**ADDENDUM SKETCH**

# BICENTENNIAL SQUARE LANDSCAPE PLAN

CITY OF CONCORD NEW HAMPSHIRE

SCALE: 1" = 10'  
SHEET 2 OF 9  
OCTOBER 2005  
REVISED: NOVEMBER, 2005 (NOTES)  
JANUARY, 2006 (SCULPTURE)

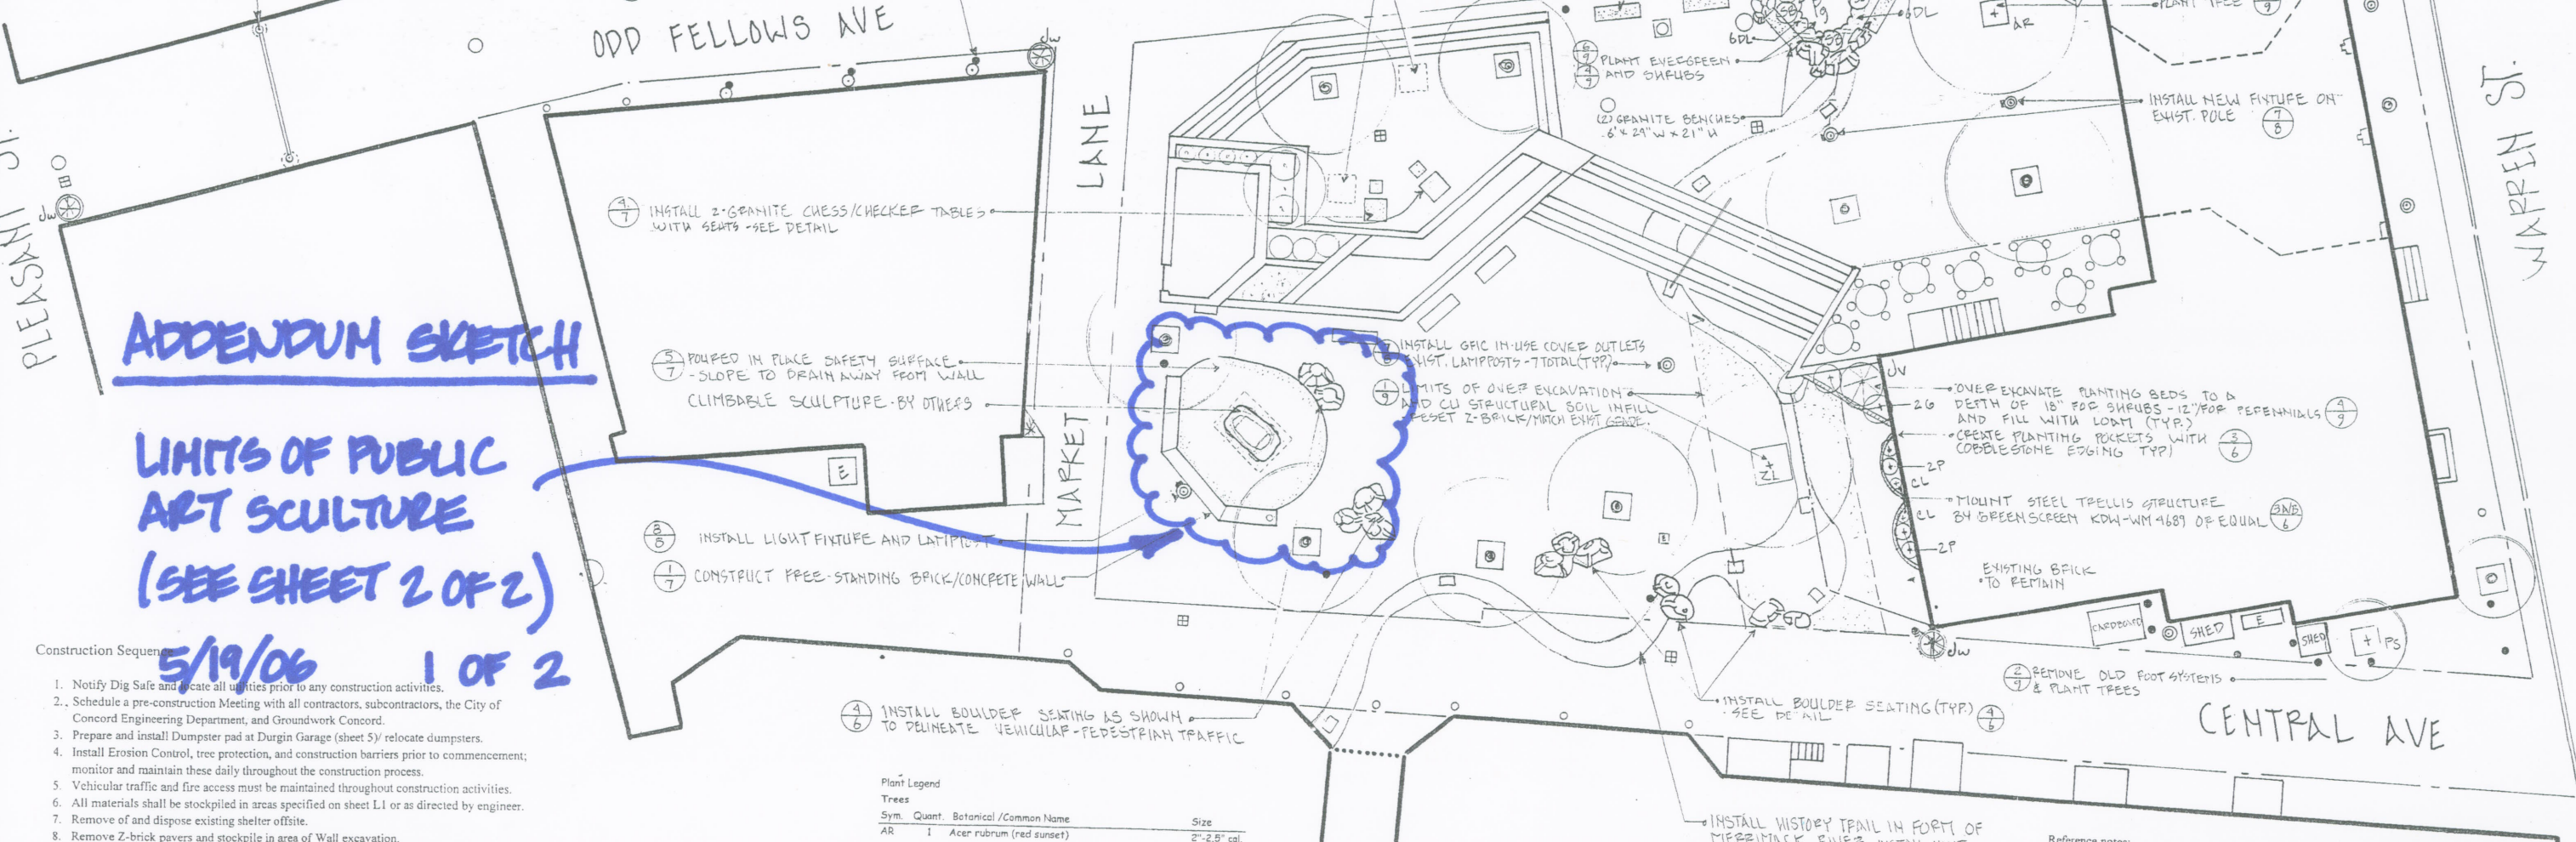
INSTALL 2-STEEL ARCHES AT PLEASANT AND WARREN STREETS WITH FIBEROPTIC LIGHTING BY DUMONT DESIGN OR EQUAL

6'x24" W x 18" H GRANITE BENCHES (1 TOTAL) BY SWENSON GRANITE OF EQUAL. SET ON EXISTING PAVED GRADE

INSTALL STEEL BECH WITH FIBEROPTIC LIGHTING OPTION - SEE UTILITY PLAN SHEET A

5'-5 1/2" x 8" BLACK PLASTIC PLANTERS BY SHARON POTTER OF EQUAL. PLANT EACH WITH UPRIGHT EVERGREEN - JW (TYP)

MEPPIMACK FINE INTERPRETIVE SIGNAGE SIGN BY METAL PHOTO OR EQUAL. AFFIX TO MARGARITA BUILDING AT EYE LEVEL

INSTALL BOULDER SEATING AS SHOWN TO DELINEATE VEHICULAR-PEDESTRIAN TRAFFIC

MOUNT STEEL TRELIS STRUCTURE CL BY GREEN SCREEN KDW-WM 4689 OF EQUAL

INSTALL HISTORY TRAIL IN FORM OF MEPPIMACK PINE. INSTALL UNIT PAVERS AND 12 GRANITE HISTORY TILES
